**Economic and Social Council**

World Forum for Harmonization of Vehicle Regulations**Working Party on Lighting and Light-Signalling****Sixty-eighth session**

Regulation No. 10 (Electromagnetic compatibility)**Proposal for the 05 series of amendments to Regulation
No. 10 (Electromagnetic compatibility)****Submitted by the experts from OICA***

Figure 4
Vehicle in configuration "REESS in charging mode coupled to the power grid"

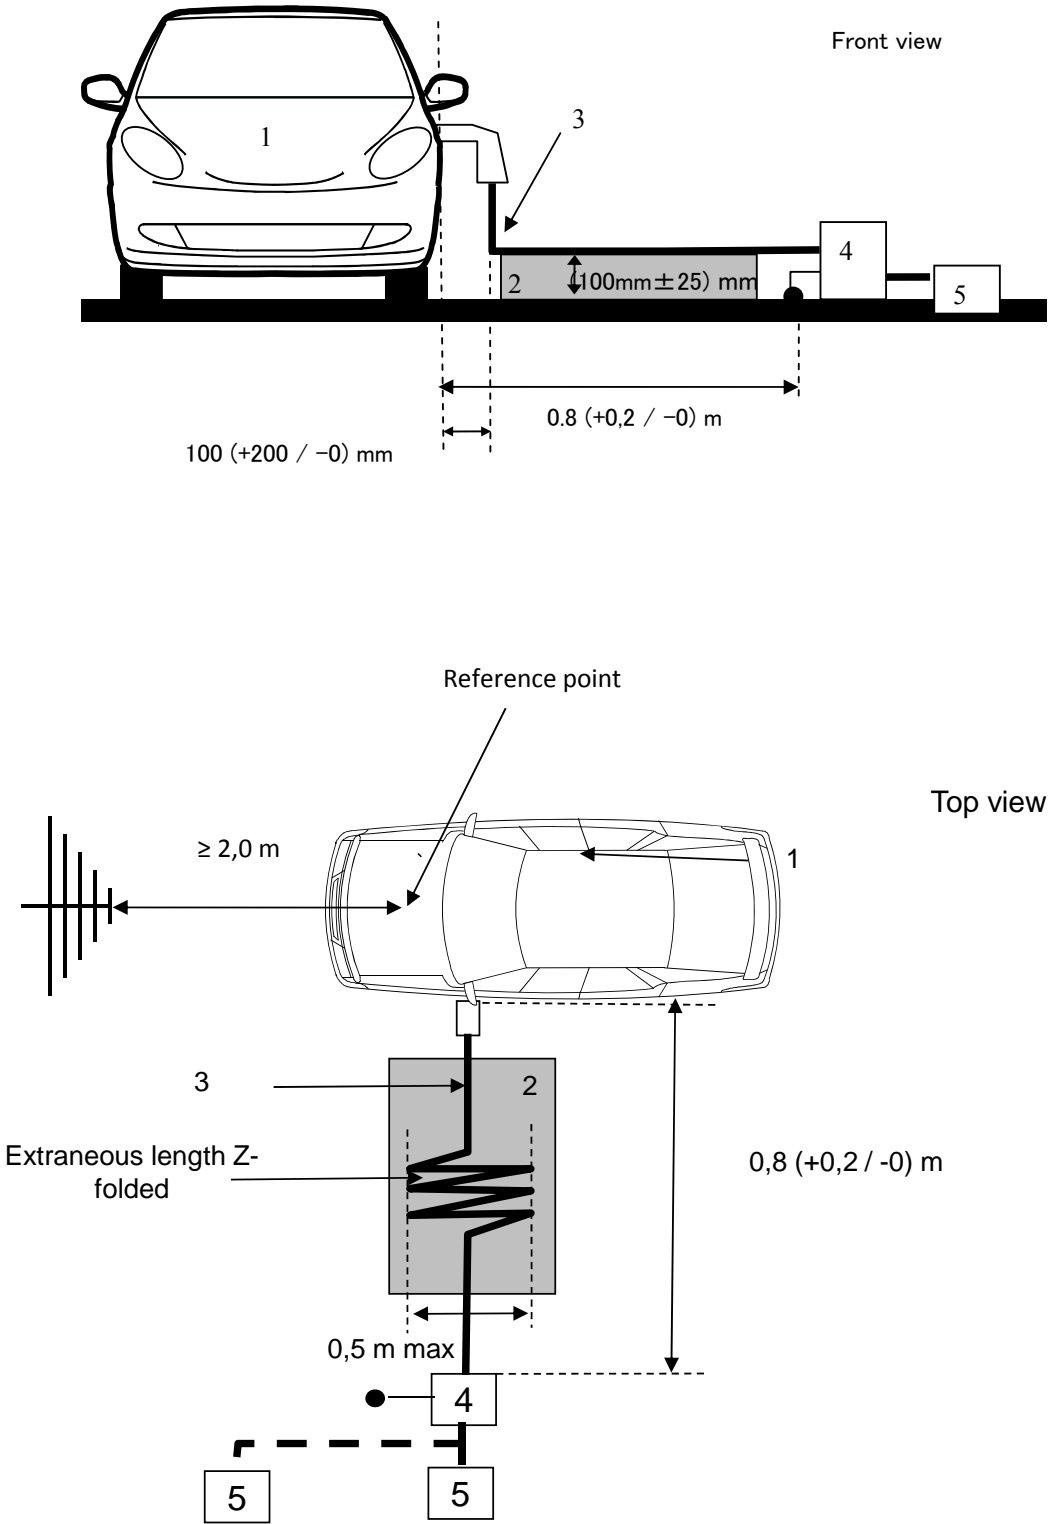
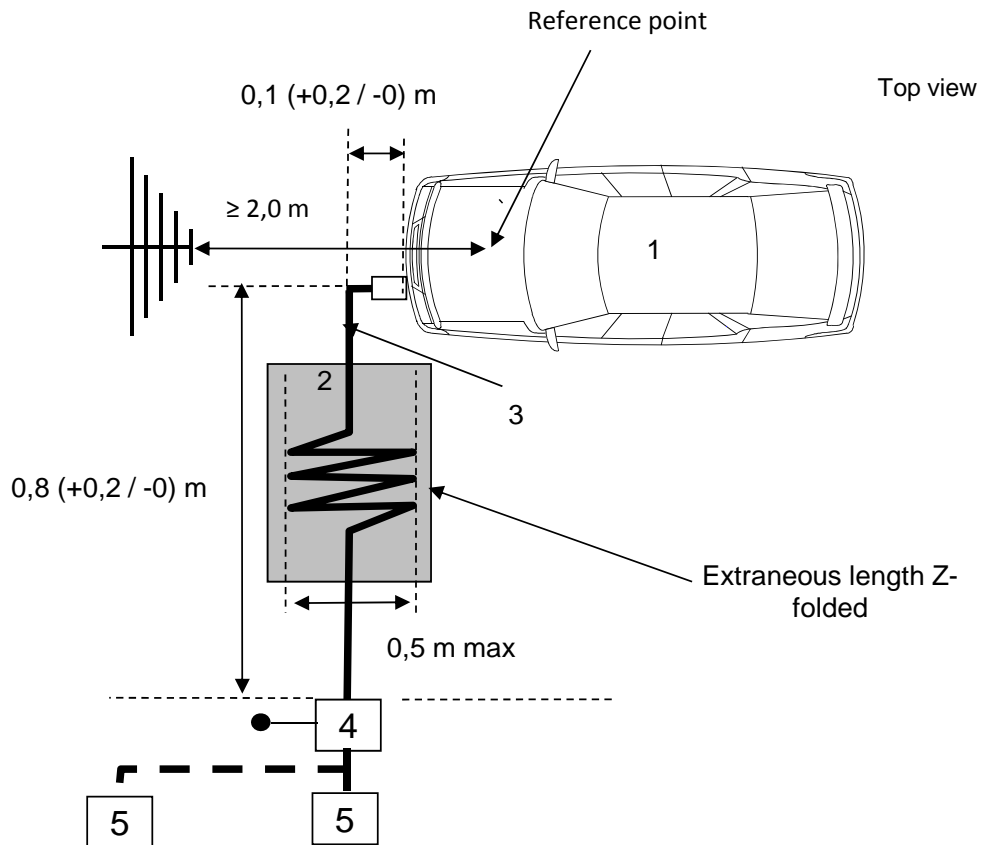
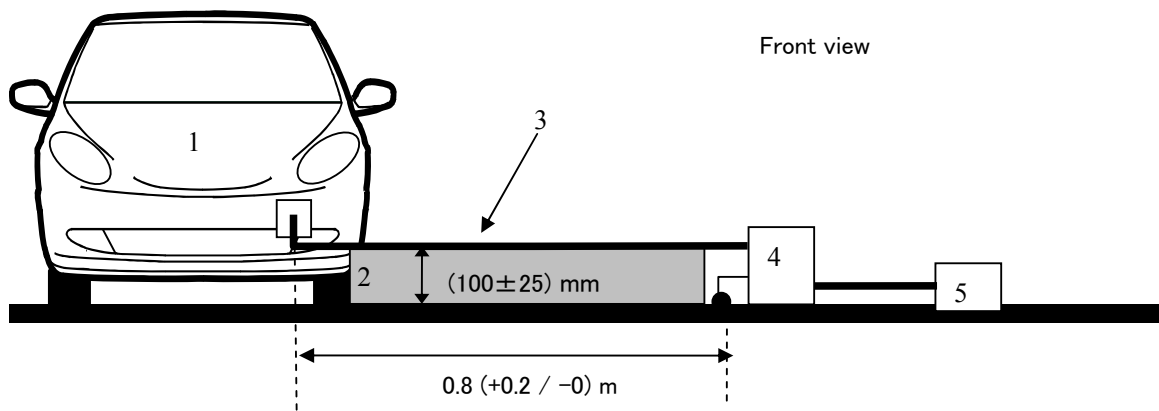
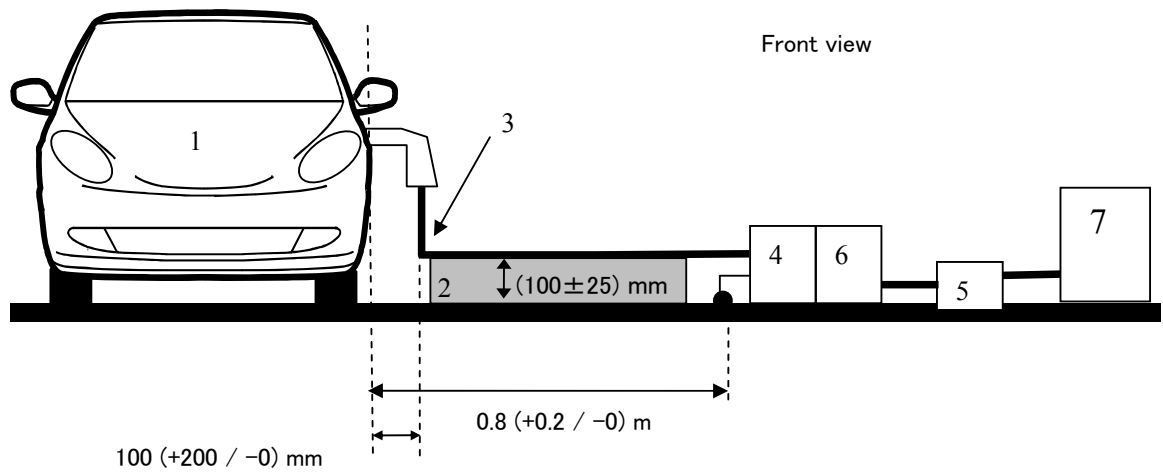
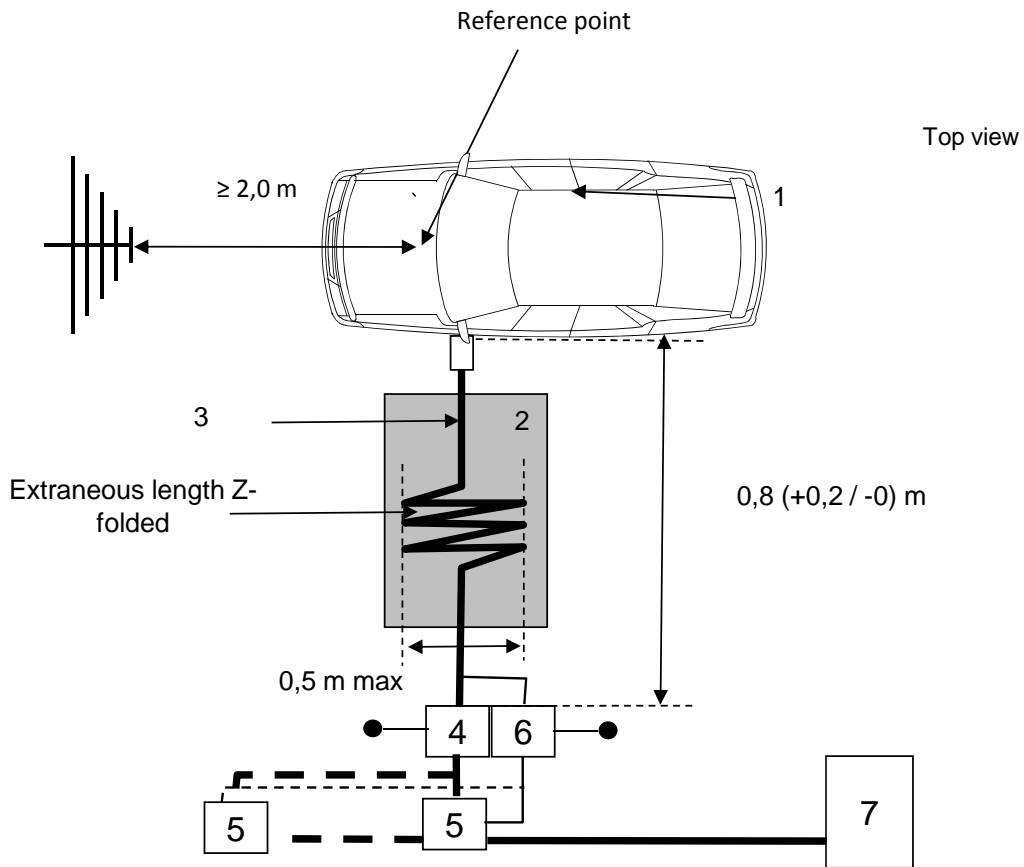
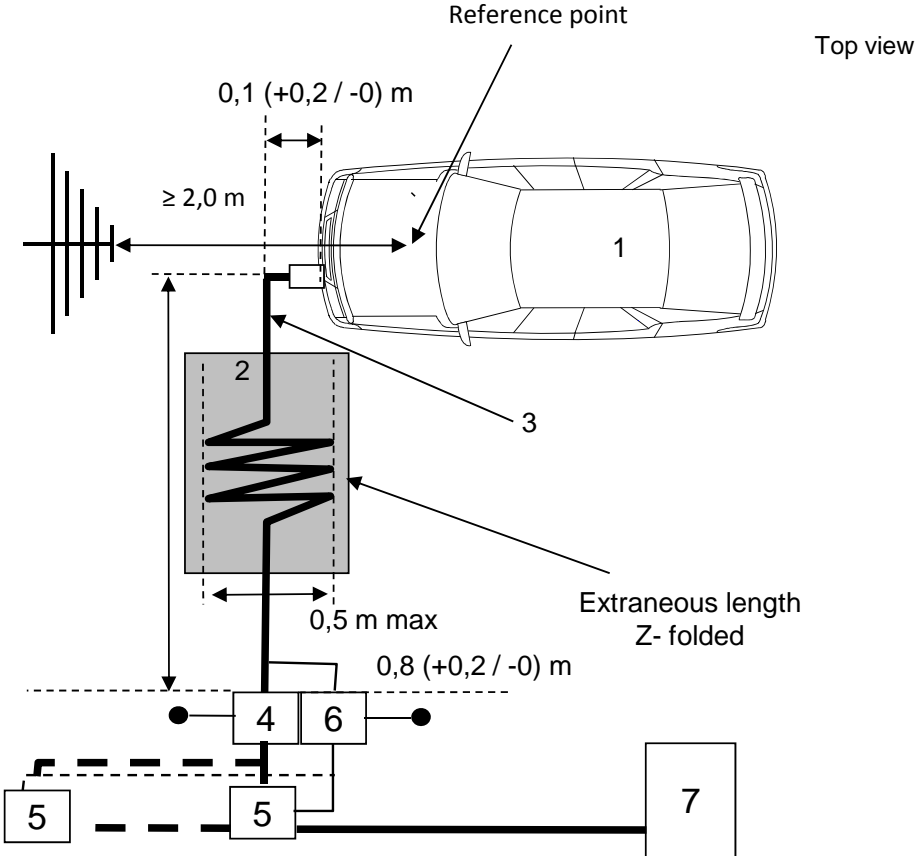
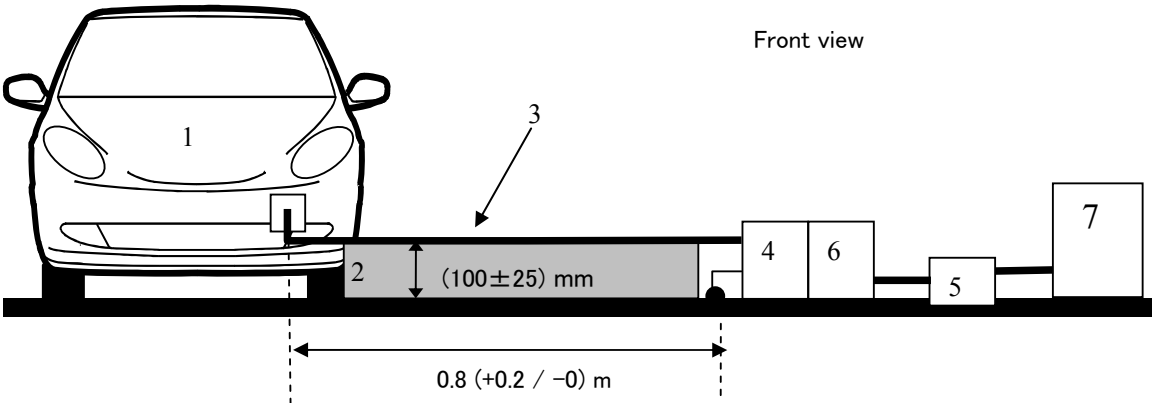
"2.2.3. The test set-up for the connection of the vehicle in configuration "REESS ~~in~~ charging mode coupled to the power grid" is shown in Figure 4a to 4h (depending of AC or DC power charging mode, location of charging plug and charging with or without communication) of Appendix 1 to this annex.

The AN shall be placed as defined in Figure 4a to 4h.

The IS shall be placed as defined in figure 4e to 4h.

Figure 1

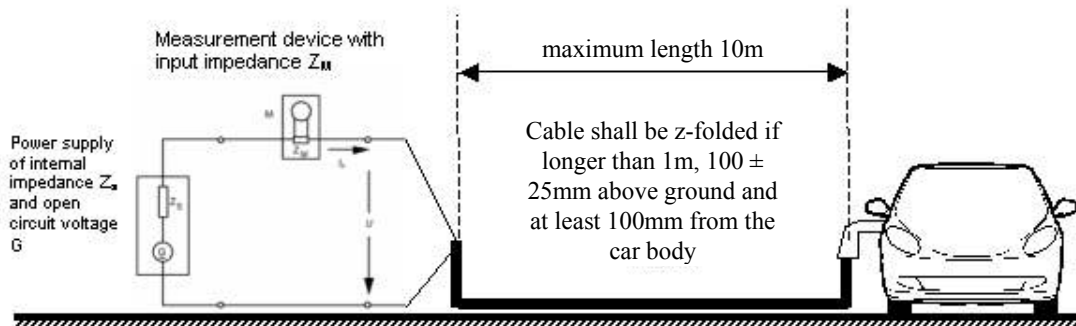
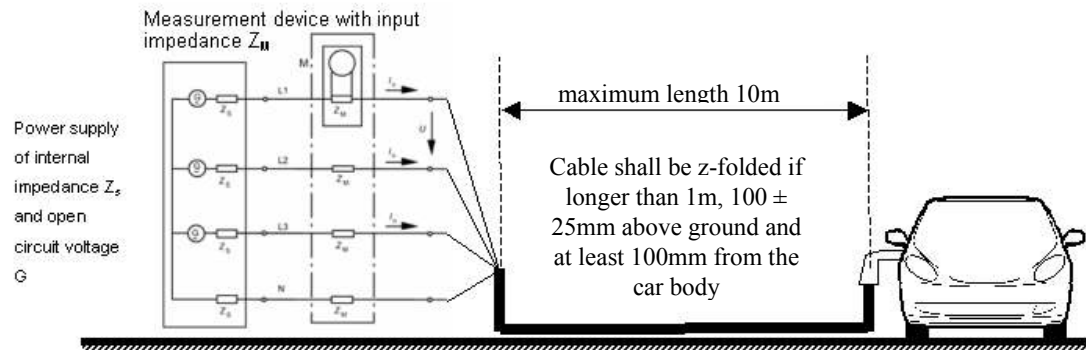
- 3.2. The test set-up for single phase vehicle in configuration “**REESS** charging mode coupled to the power grid” is shown in Figure 1 of Appendix 1 to this Annex.

- 3.3. The test set-up for three-phase vehicle in configuration “**REESS** charging mode coupled to the power grid” is shown in Figure 2 of Appendix 1 to this Annex.

Figure 1

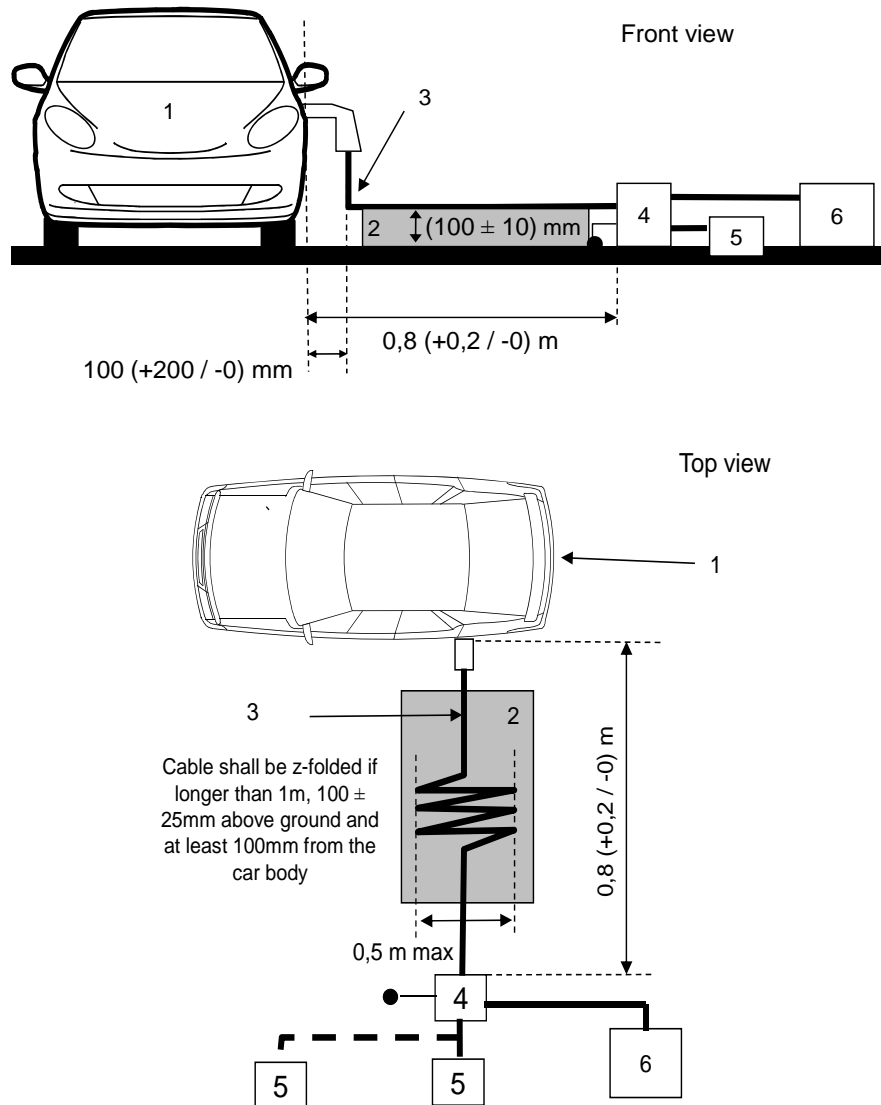
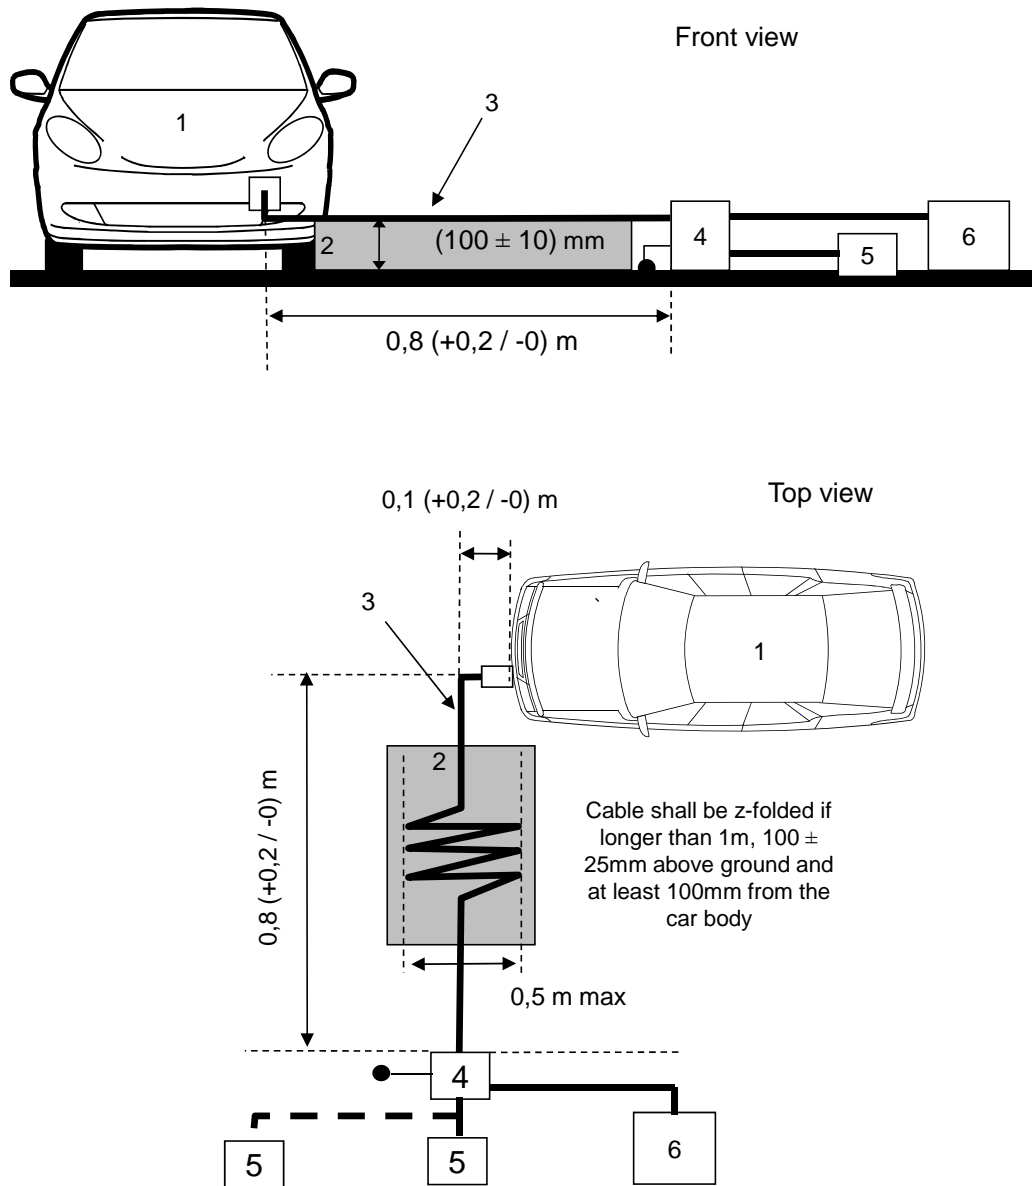
The AN shall be placed as defined in Figures 1a to 1d.
 - 3.3. The test set-up for the connection of the vehicle in configuration "REESS charging mode coupled to the power grid" is shown in figure 1 of Appendix 1 to this annex.

Figure 1

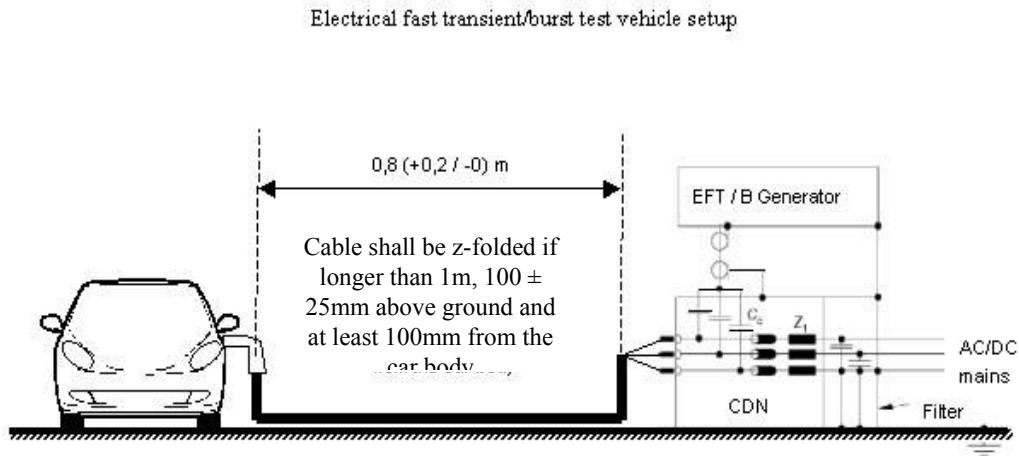
The vehicle shall be positioned on the ground plane. The electrical fast transient/burst (EFT/B) shall be applied on the vehicle on the AC/DC power lines in common modes by using CDN as described in Appendix 1, Figure 1 of this annex.

Figure 1

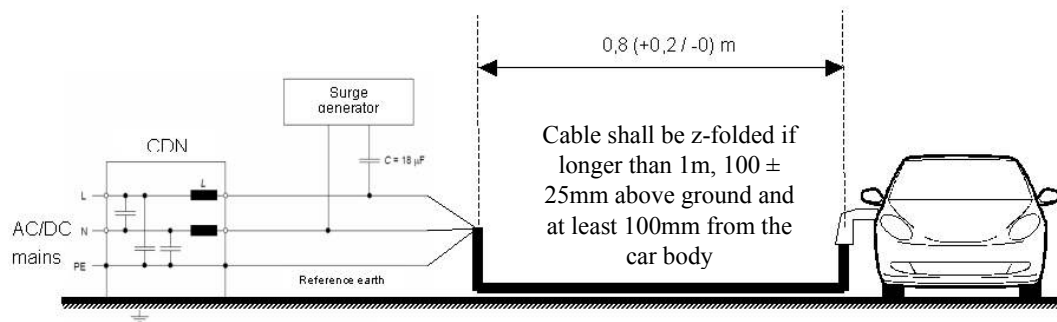
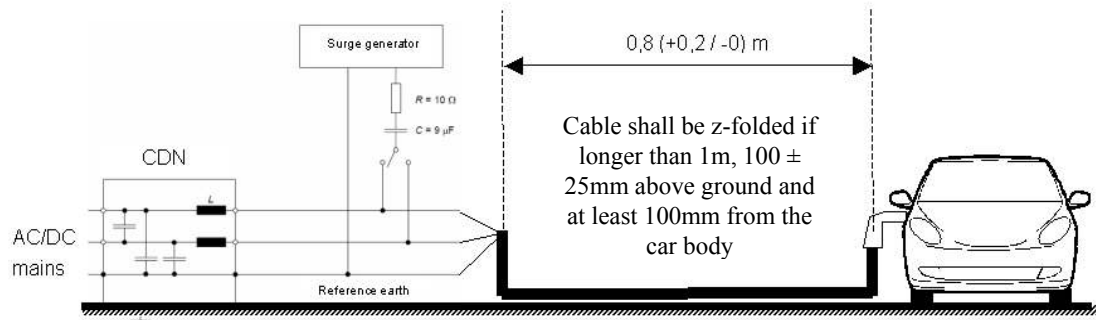
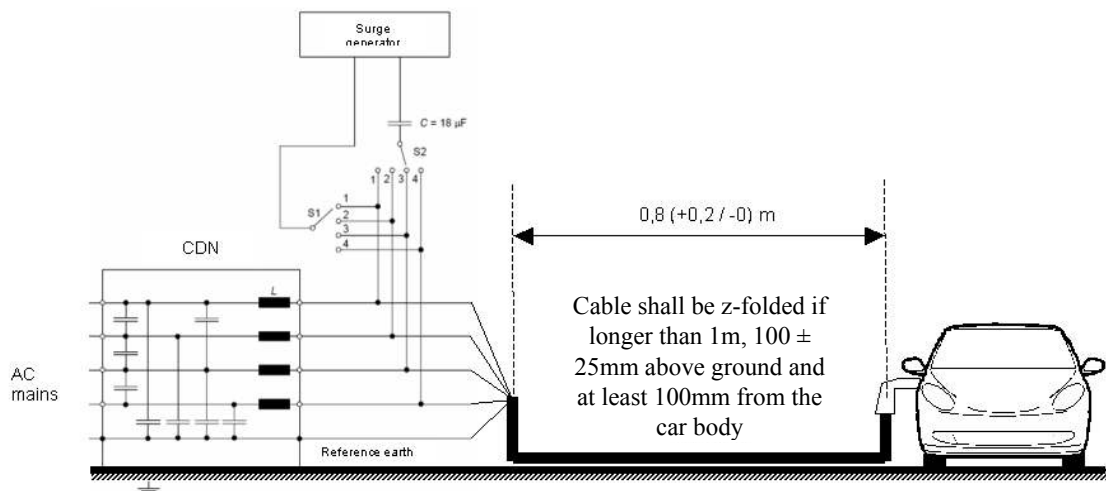
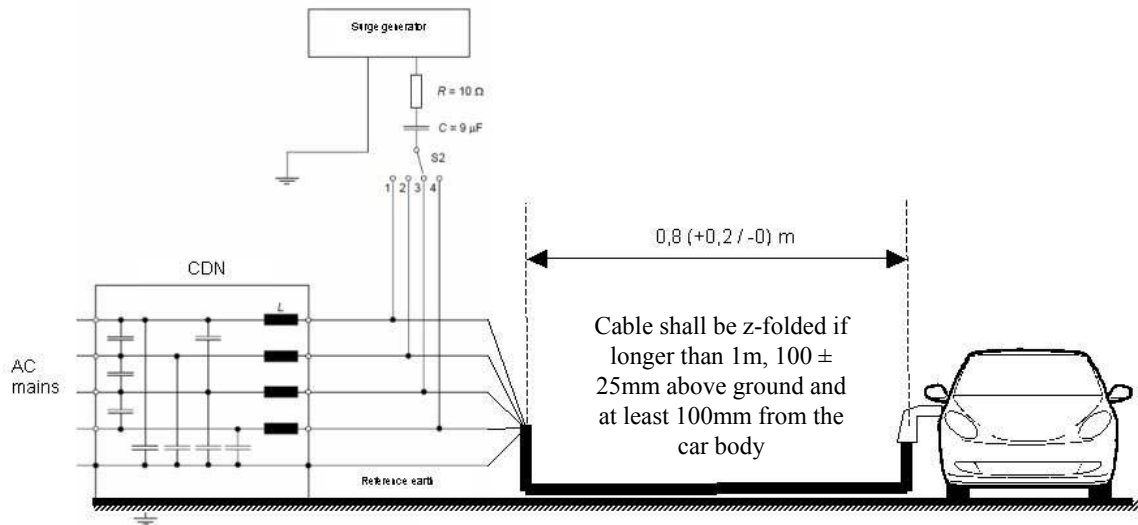
The vehicle shall be positioned on the ground plane. The electrical surge shall be applied on the vehicle on the AC/DC power lines between each line and earth and between lines by using CDN as described in Appendix 1, Figure 1 to 4 of this annex,
